INDIANTOWN COGENERATION PROJECT

SITE CERTIFICATION APPLICATION SUFFICIENCY RESPONSES

April 1991

INDIANTOWN COGENERATION L.P.'S
NOTICE OF FILING RESPONSES TO
SUFFICIENCY QUESTIONS OF
THE DEPARTMENT OF ENVIRONMENTAL REGULATION
AND OTHER AGENCIES

**ATTACHING LINER TO
CONCRETE STRUCTURE**

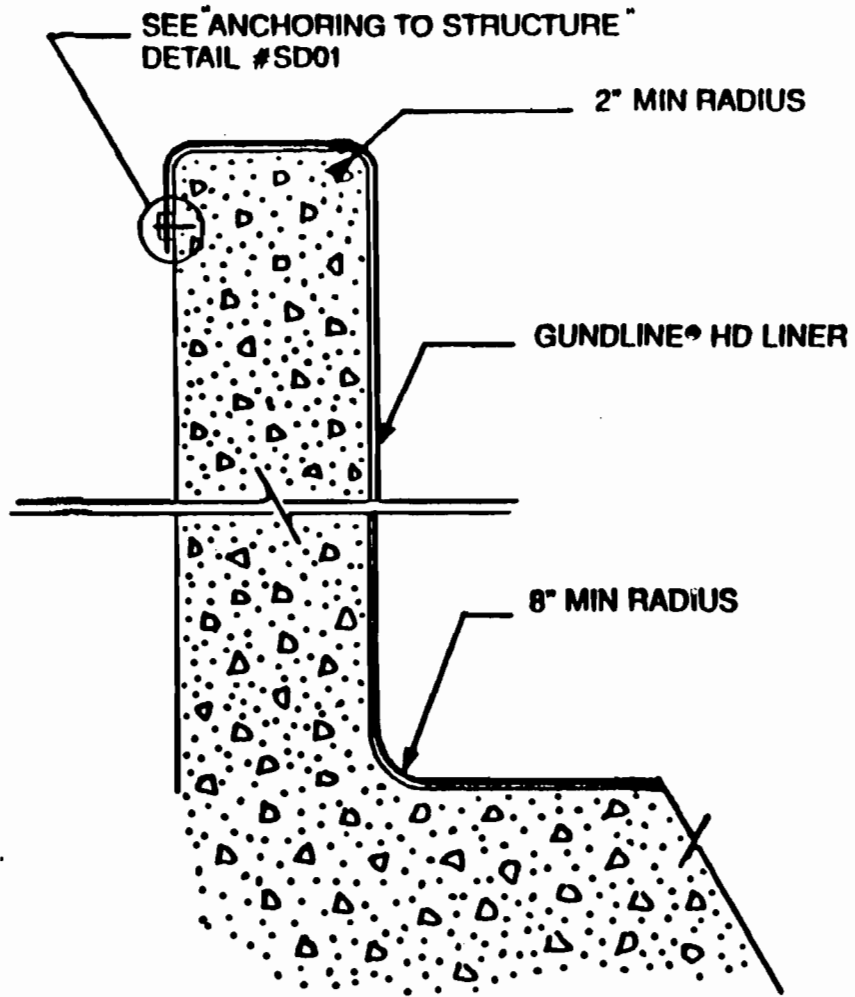
There were no construction specifications or drawings included with the application, e.g. no detail on liner construction for the cooling water storage pond, coal storage areas or run-off treatment basin.

The typical details of the anchoring of the liner to the structure, connection of inlet/outlet flange sealing of steel and HD pipe system, anchor trench detail, side slope protection, concrete sump detail, attaching liner to concrete structure, liner blow-out prevention, V-anchor trench, and typical wedge weld detail are shown on the attached detail sheets of Gundle Lining system (Exhibit FDER1-4).

Exhibit FDER20-1
 ELEVATION, AREA, AND CAPACITY CURVES OF
 LAKE OKEECHOBEE

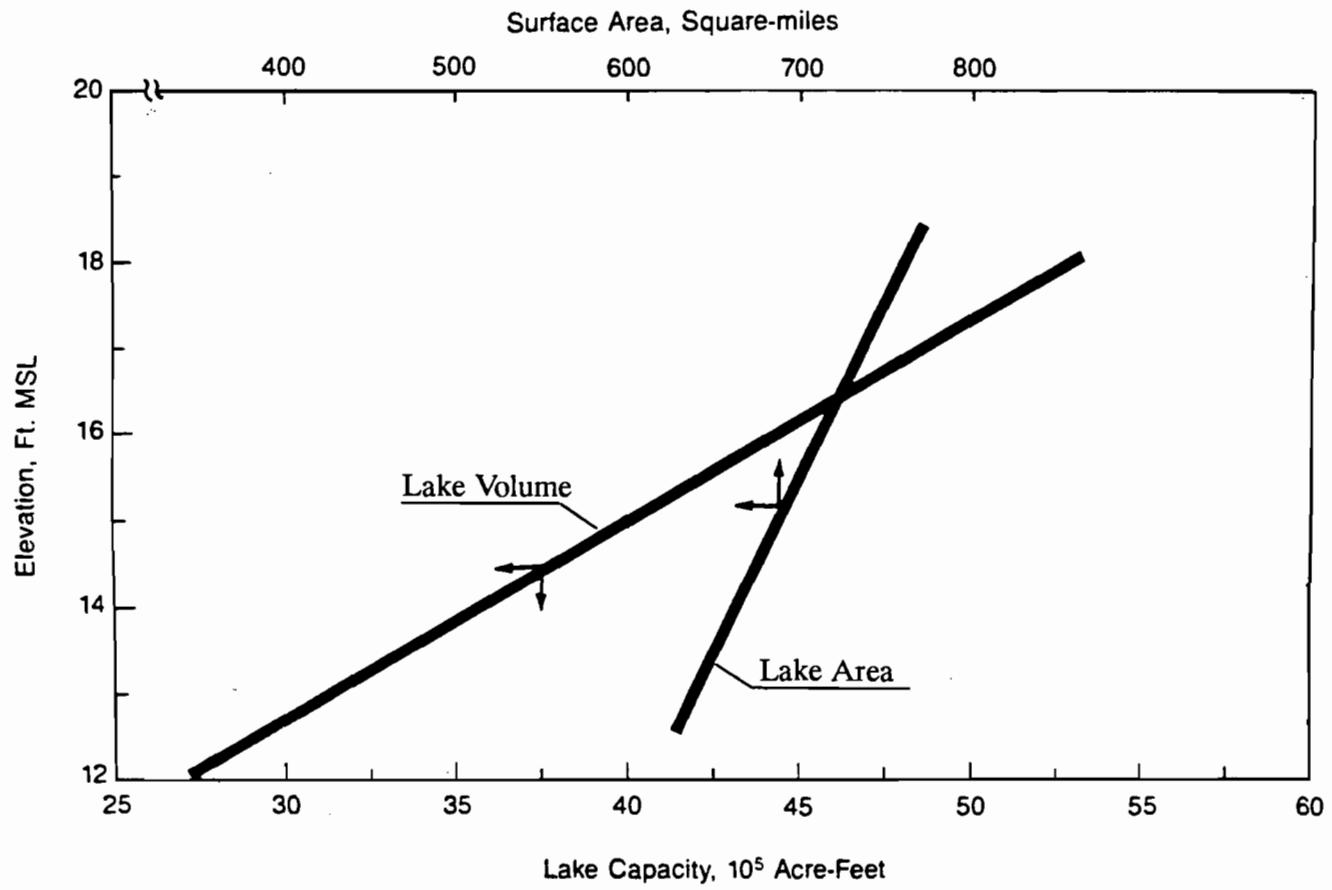
The curves on Figure 2.3.4-3 need to be labeled.

The arrows on curves of Exhibit DER20-1 are directed to the coordinate system used for each particular quantity. Each curve is also labeled.
